# Access Compliance Report

## Public Rights-of-Way

### (Curb Ramps)

Intersection ID: 49691	Main Street: OLIVIA_VIEW_CT	Cross Street: ALEXANDRA_ALLEY_DR	Location: W
ADA ID: 607992E181EB	Ramp Type: Perp	Initial Pass/Fail: Fail	Overall Compliance: No
Severity Score: 22.5			
Codes/Mitigation Info/Possible Solution		Field Measurements/Component Compliance

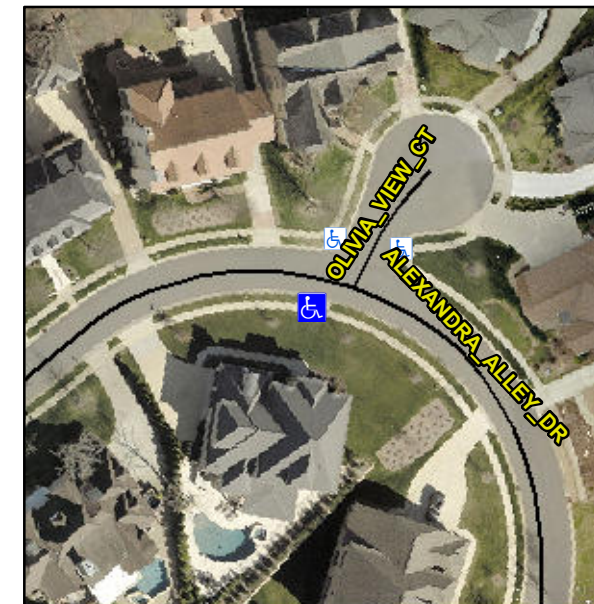
**R304.5.1, R304.2.2, R304.5.3**

Compliance	Description	Data	Compliance	Description	Data
N/A	Ramp Length (in)	47.5	No	Ramp Slope (%)	10.8
No	Ramp Width (in)	47.0	No	Ramp XSlope (%)	2.7
N/A	Flare Type LT	N/A	N/A	Flare Type RT	N/A
N/A	Flare Slope LT (%)	N/A	N/A	Flare Slope RT (%)	N/A
N/A	Flare Traversable LT?	N/A	N/A	Flare Traversable RT?	N/A
N/A	Landing Length (in)	N/A	N/A	DWS Provided?	N/A
N/A	Landing Width (in)	N/A	N/A	DWS Contrast?	N/A
N/A	Landing Slope (%)	N/A	N/A	DWS Length (in)	N/A
N/A	Landing X Slope (%)	N/A	N/A	DWS Full Width?	N/A
N/A	Landing Curb? (Y/N)	N/A	N/A	DWS Offset (in)	N/A
N/A	Shared Landing?	N/A			
N/A	Gutter Ponding?	N/A	N/A	Gutter Slope (%)	N/A
N/A	Gutter Lip Ht (in)	N/A	N/A	Gutter X Slope (%)	N/A
N/A	Painted X Walk1?	No	N/A	Painted X Walk2?	N/A
	X Walk 1 Direction	To NE		X Walk 2 Direction	N/A
N/A	X Walk 1 Width (in)	N/A	N/A	X Walk 2 Width (in)	N/A
	X Walk 1 Slope (%)	2.8		X Walk 2 Slope (%)	N/A
	X Walk 1 X Slope (%)	2.1		X Walk 2 X Slope (%)	N/A

**Remove & Replace Entire Ramp.**
